SUBJECT: WORKPLAN ADDENDUM
Albany Hill Mini Mart
800 San Pablo Avenue
Albany, California

**PROPOSED BORING
LOCATION MAP**

AQUA SCIENCE ENGINEERS	Figure 4
------------------------	----------

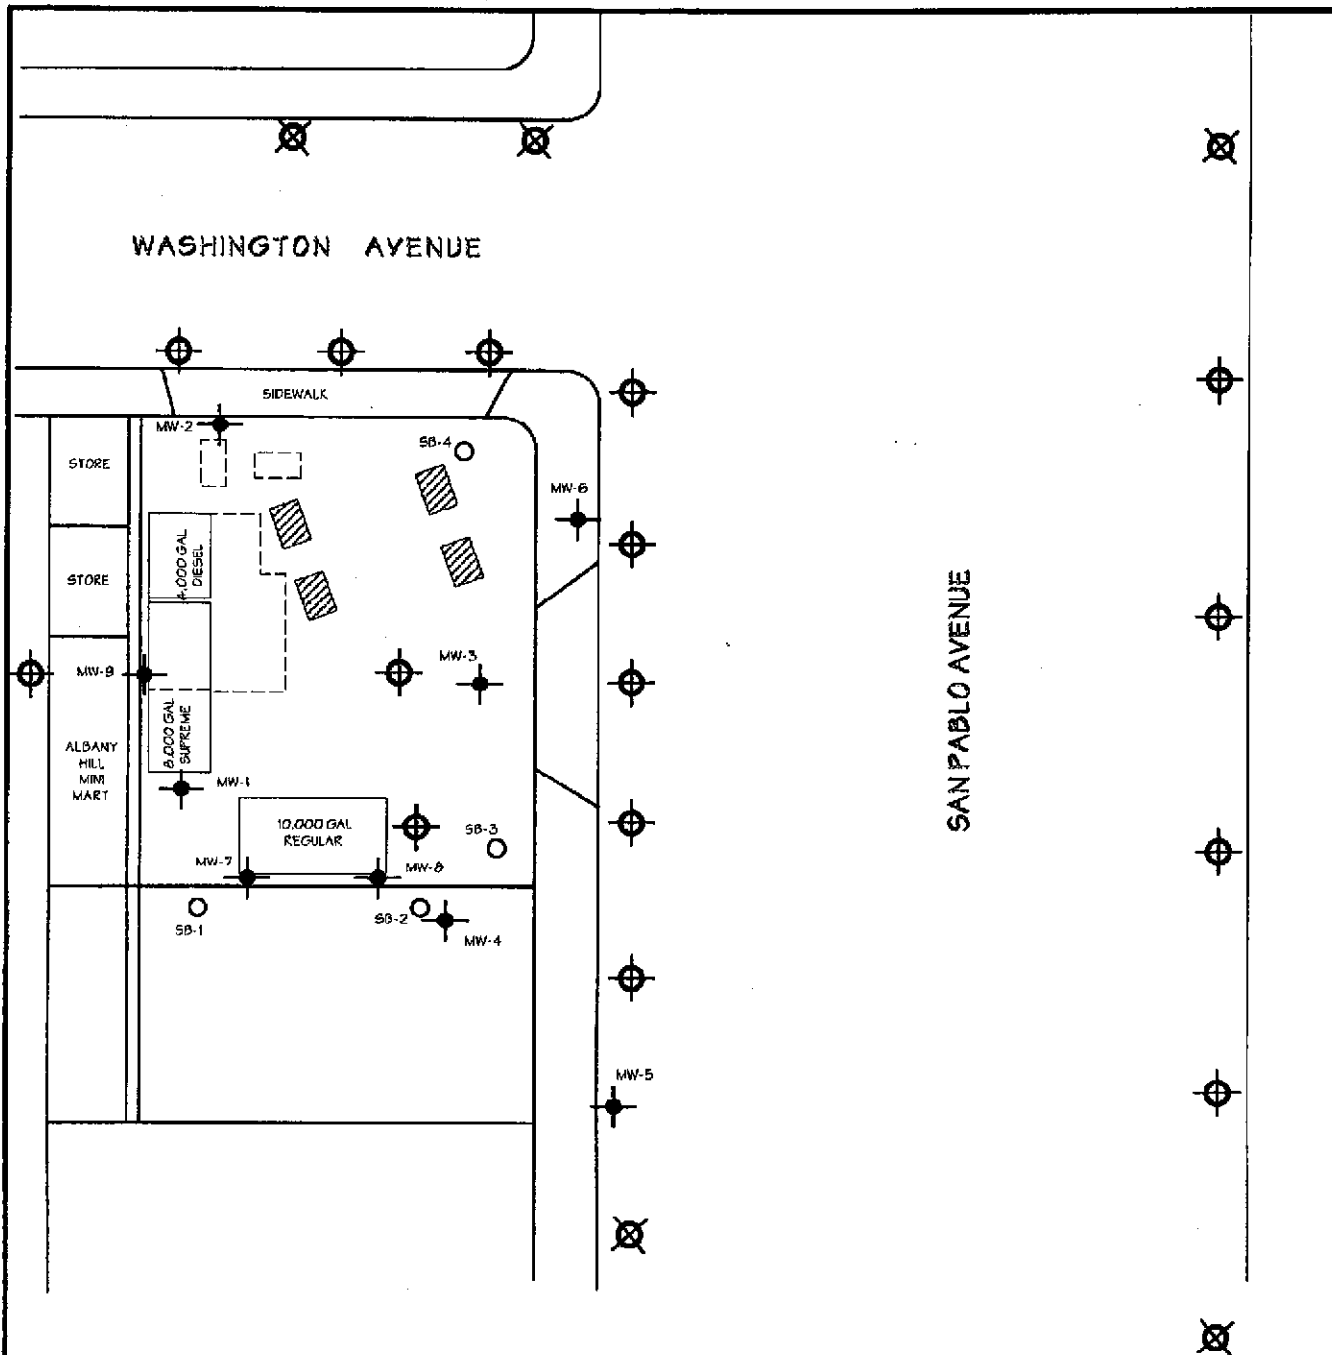
Per our telephone conversations regarding modifications to boring locations for the above referenced site, attached is a drawing showing a compromise of boring locations to be drilled at the site. A total of 15 soil borings will be drilled with the possibility of 5 additional step-out borings to be completed if necessary based on the results of closer in borings. It is our understanding that the rest of the workplan is acceptable.
